**Planning & Zoning Commission Agenda  
Rochester Boards & Commissions - Planning & Zoning Commission  
August 9, 2023  
6:00 p.m.**

**5.A. Interim Use Permit No.CD2023-001 to allow for excavation of bedrock located at 2660 Broadway Ave by Sawyer Construction Services Inc.**

**Request:** Interim Use Permit Request #CD2023-001IPU to allow for excavation of bedrock located at 2660 Broadway Avenue N.

**Development Review Team Recommendation: Denial**

**Example: Height of 38' Cut**

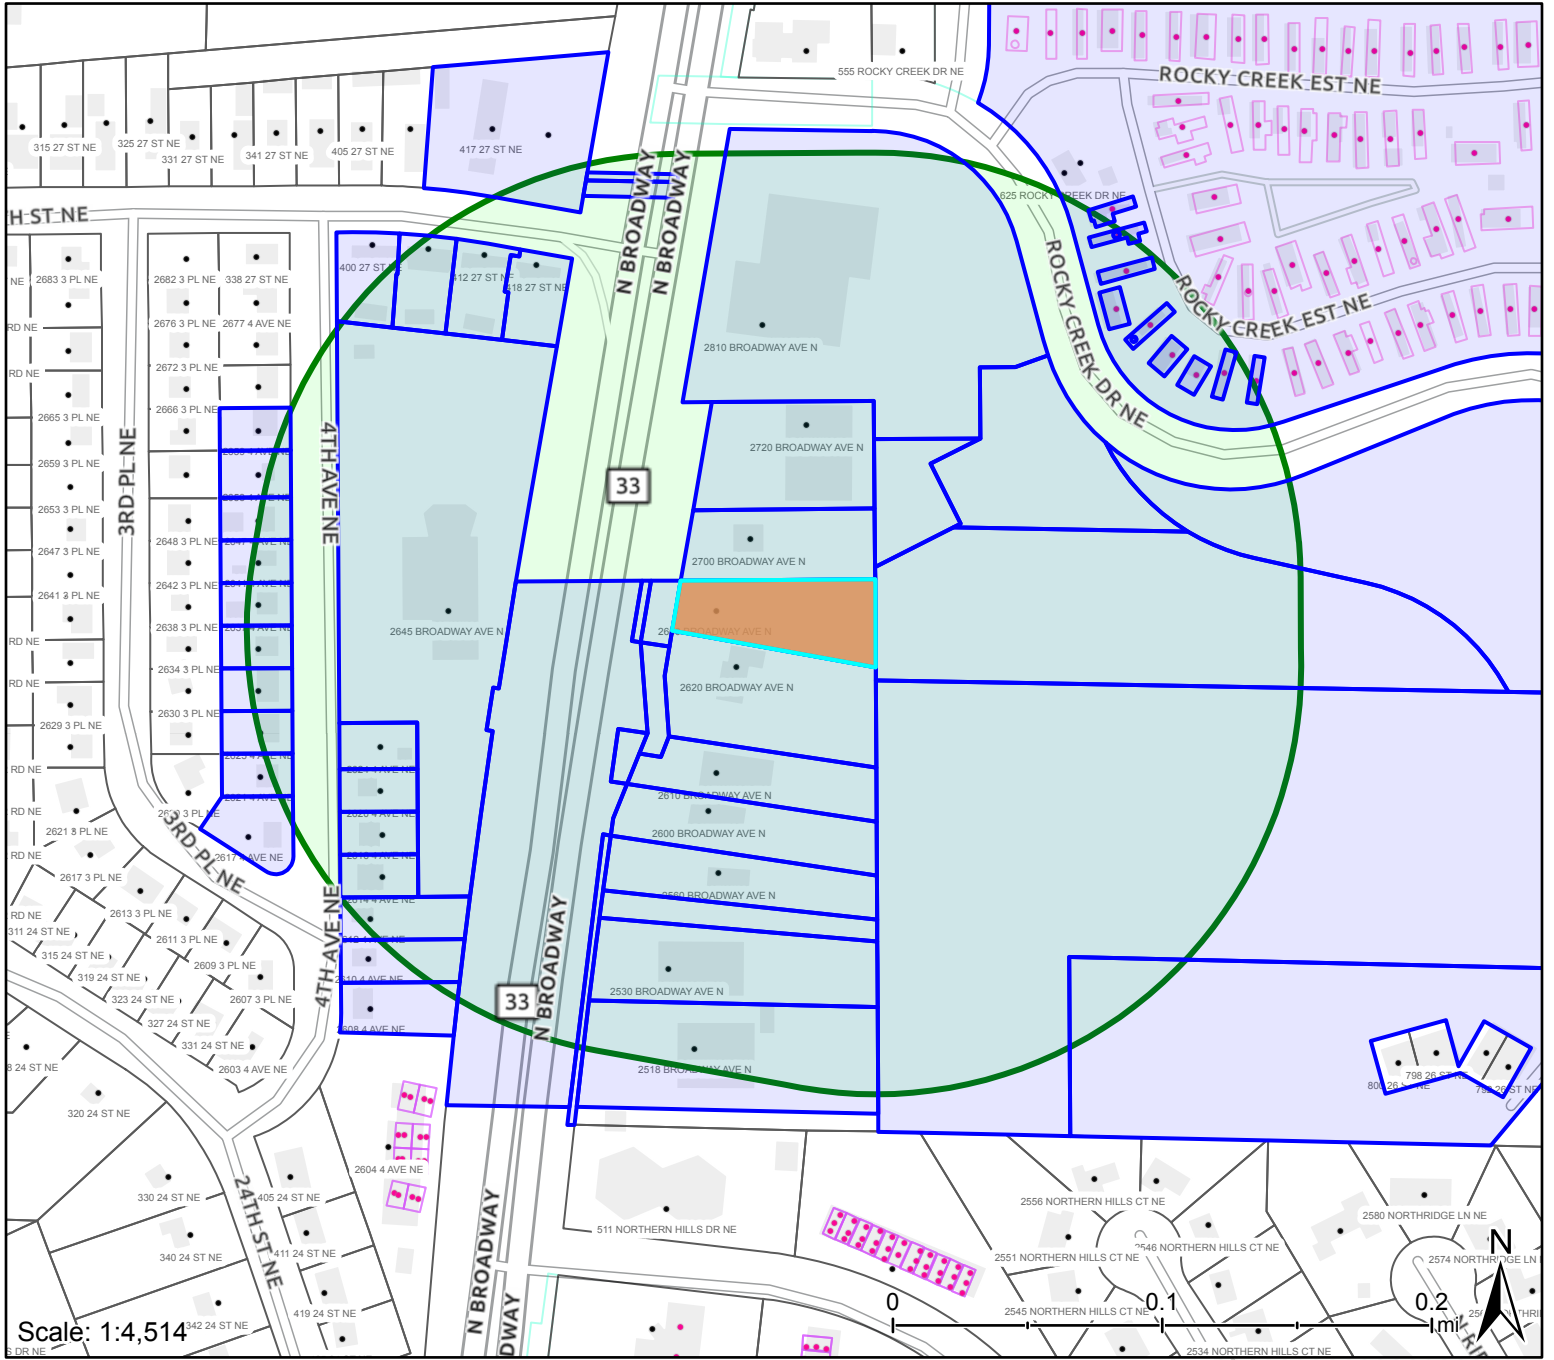
The below example is located approximately 100' south of proposed excavation. This image shows a one sided cut. The IUP request proposes a three sided cut, creating a 72 foot deep notch in the hillside. The back wall of proposed excavation ranges in height from 29 feet to 38 feet high.

**Example: 80 degree slope:**  
Demonstrates degree of bedrock slope proposed for three sides of the proposed excavation

**SITE AND LANDSCAPE PLAN**  
**PROCUT FIREWOOD**  
**ROCHESTER, MINNESOTA**

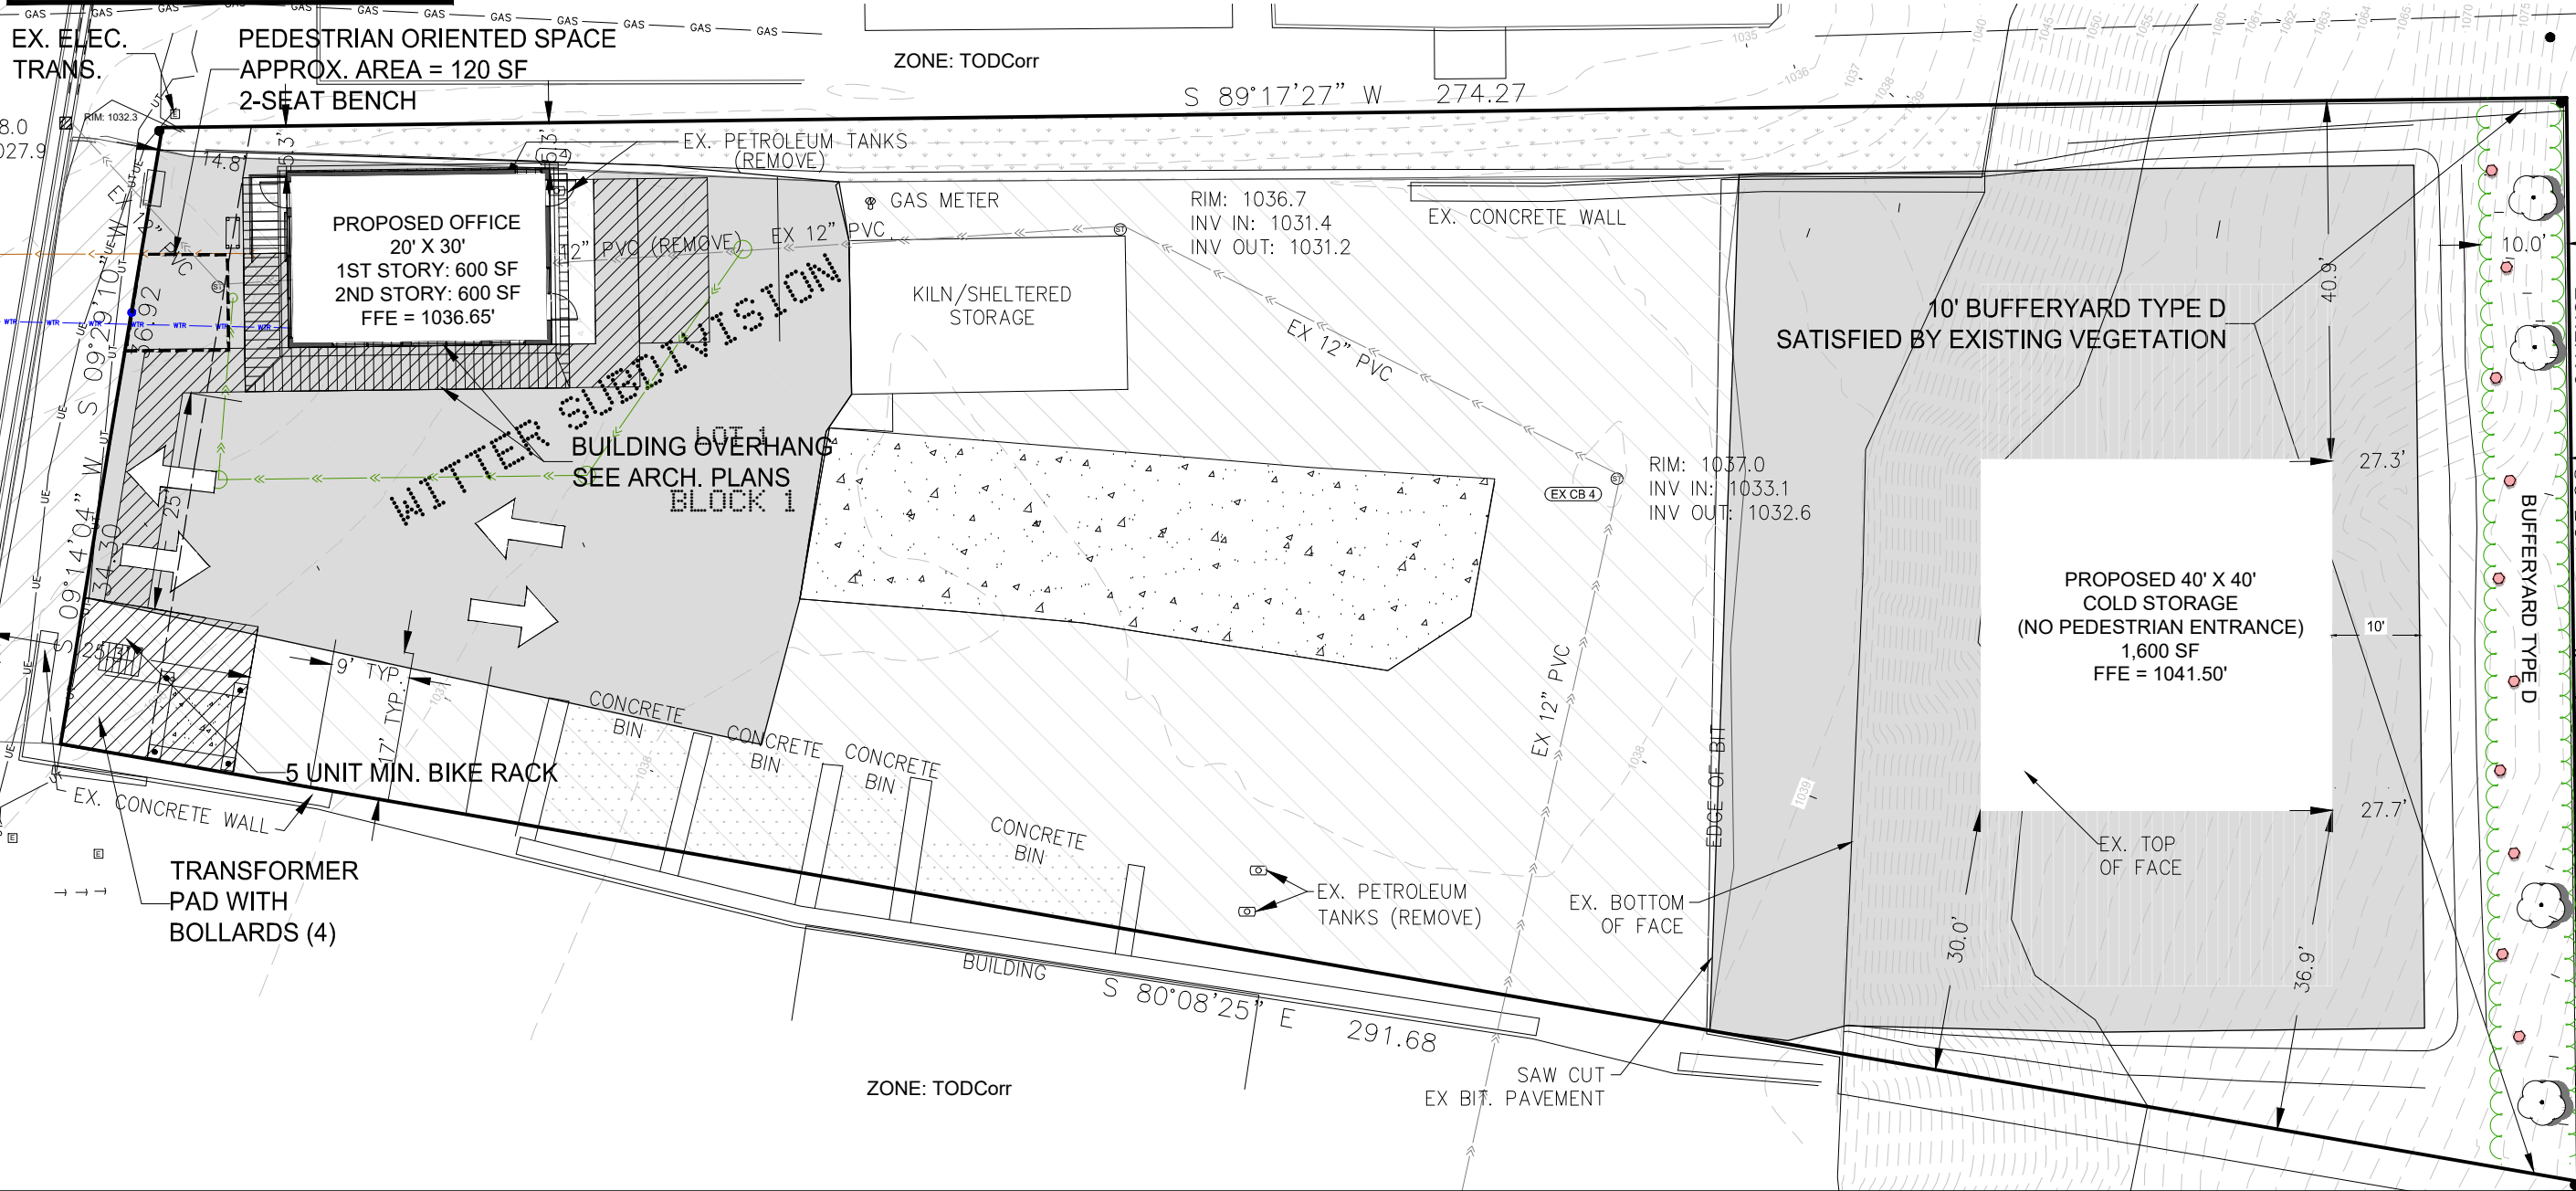
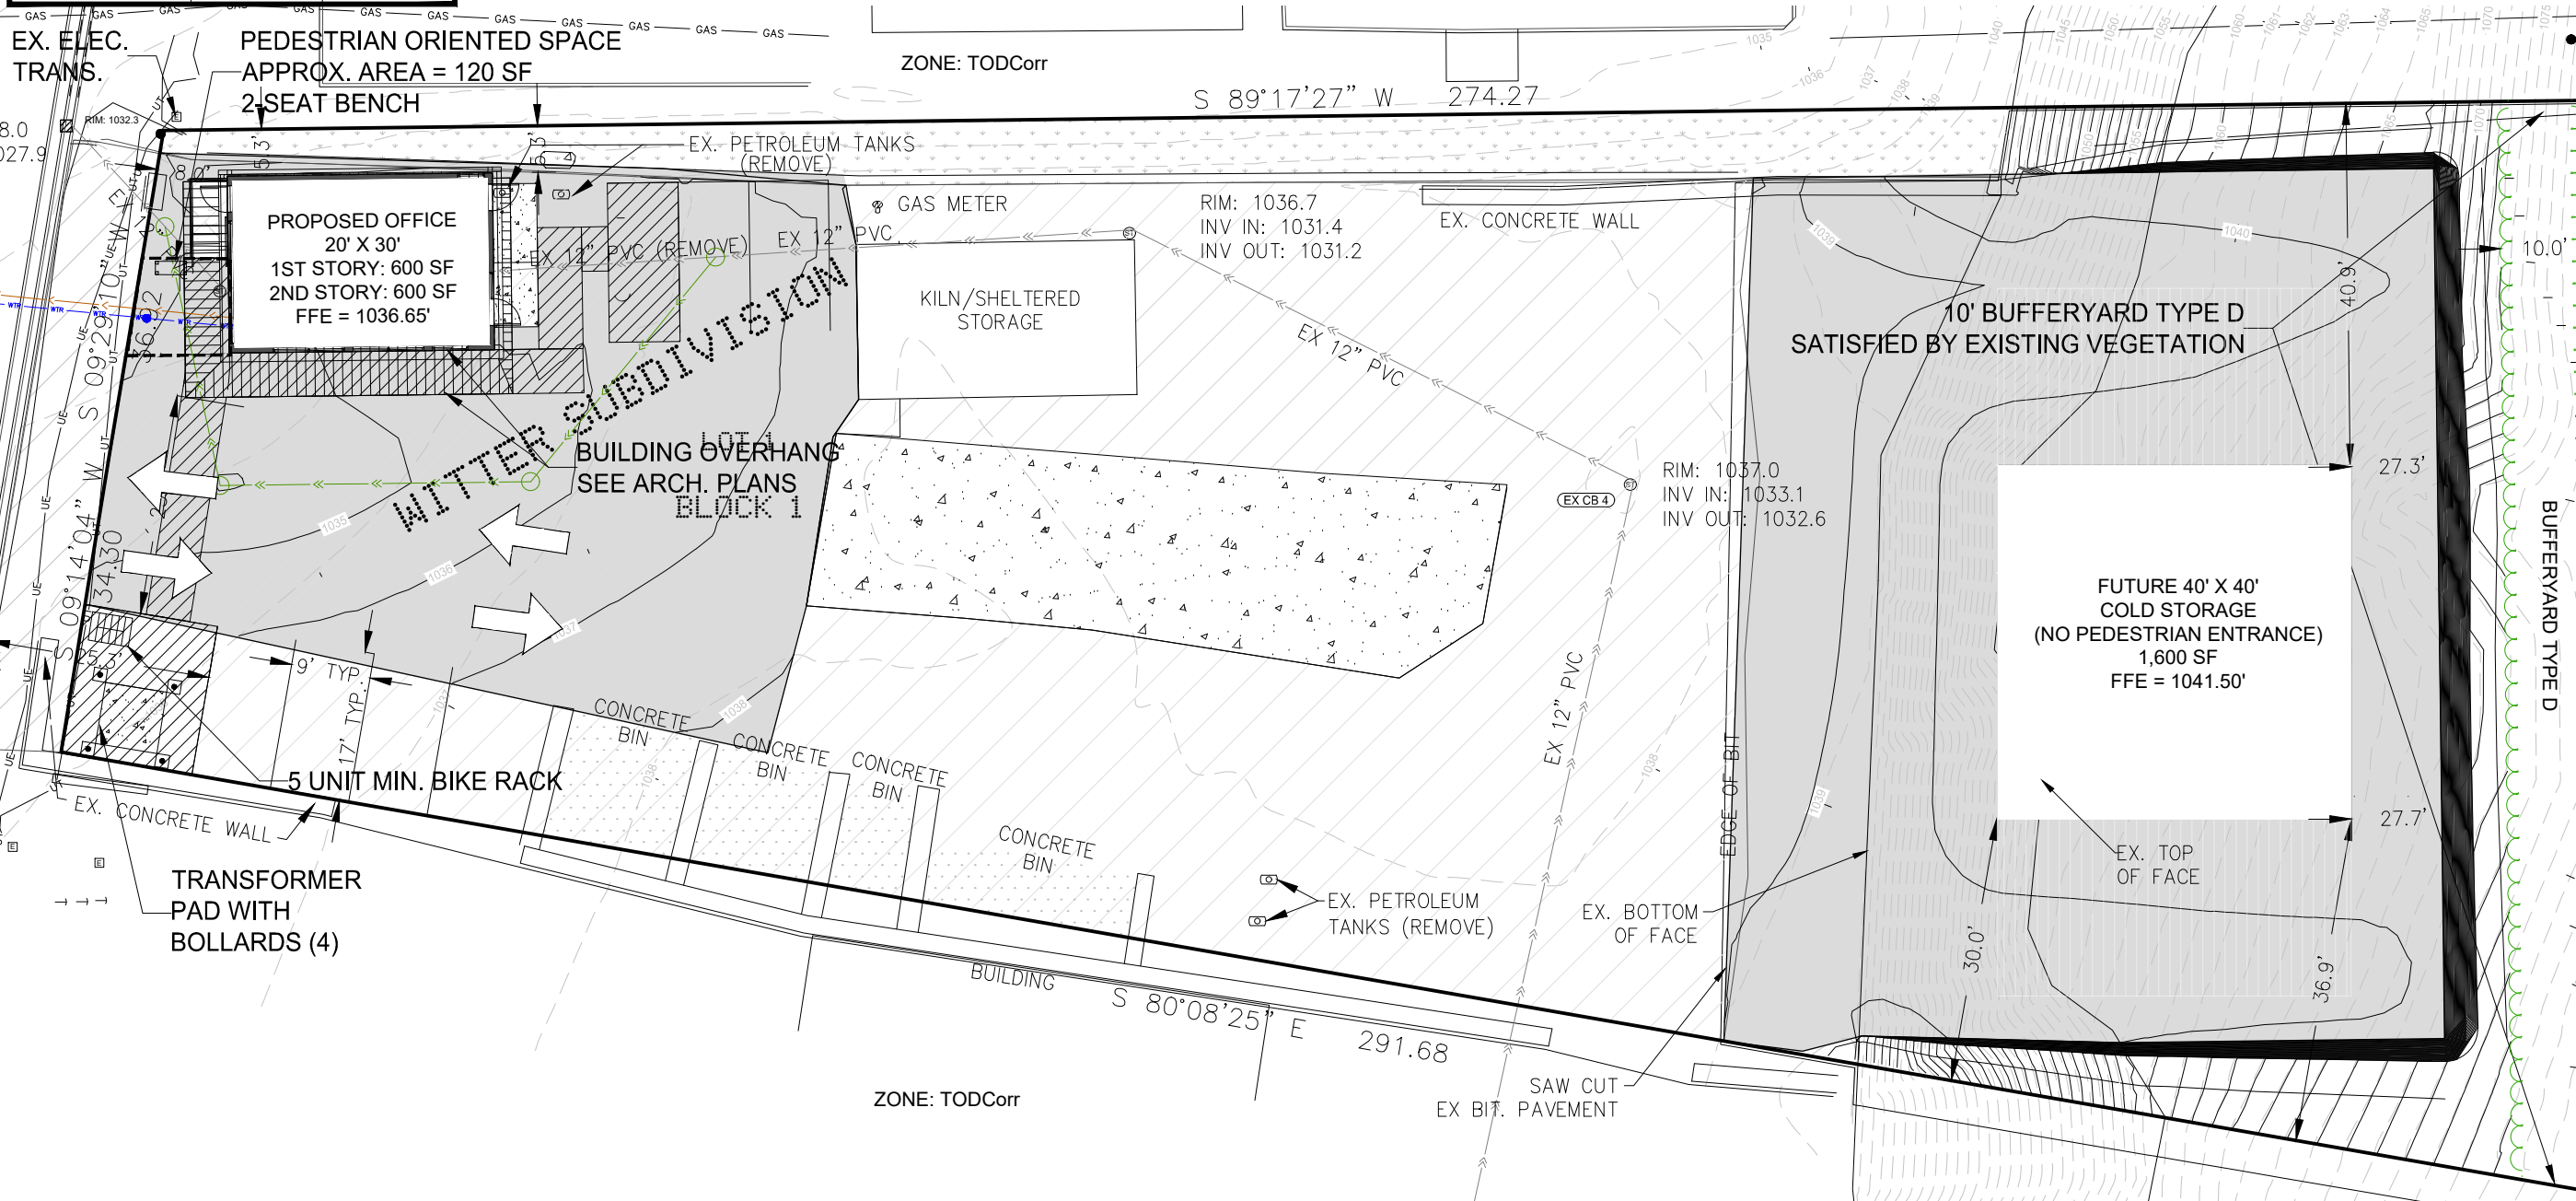
***It is the position of the Development Review Team the subject request adversely affects the scenic quality of Rochester's natural landscape and wildlife habitat. Additionally, there are concerns with possible inconsistencies between the Site Development Plan and the requirements of the Slope Stability Report relating to bufferyard plantings and removal of tall overstory trees.***

***It is probable that the bufferyard requirements are currently met with existing vegetation on the site, and the site plan shows existing vegetation that will remain in the bufferyard. However, the slope stability report recommends removal of all over story trees. The removal of all overstory trees on the site will have significant visual impact on this section of Rochester's Broadway Corridor potential increased slope erosion of the bufferyard area.***

***It is unknown how many "overstory" trees are proposed to be removed to make a complete assessment of the condition of the proposed bufferyard. Because of extent of the total area of exposed rock, more specific detailed information is needed about the vegetation that will remain above since amount of existing vegetation that will remain after excavation has significant bearing on visual character of the site.***

I have discussed these definitions and risk reduction strategies with Tyler Mandler of WSE. He is revising his tree removal and replacement plan to maintain a safe population of canopy trees.
